PRODUCT ADVISORY NOTICE

SUBJECT: Temporary color change of 76HP, 90B and 90HB DIP actuators due to plastic material shortage

Bulletin #1341

DIP Actuator Temporary Color Change Due to Material Shortage

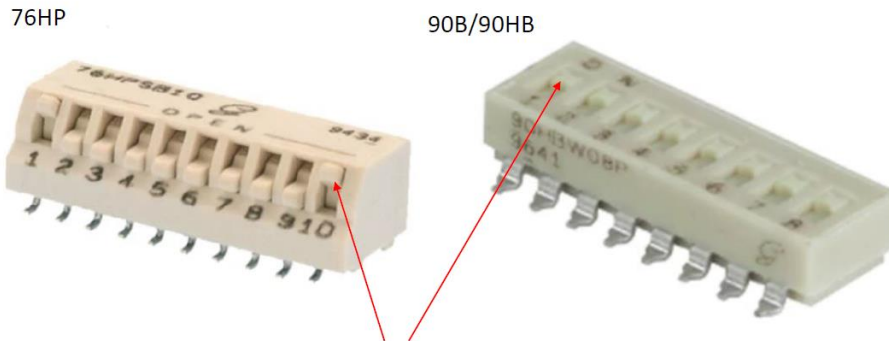
Due to a shortage of the natural colored plastic material used to mold the actuators of the affected DIP switches, the color will be temporarily changed to black to avoid production delays.

Color of DIP actuators (currently natural) will be temporarily changed to black to prevent production delays.
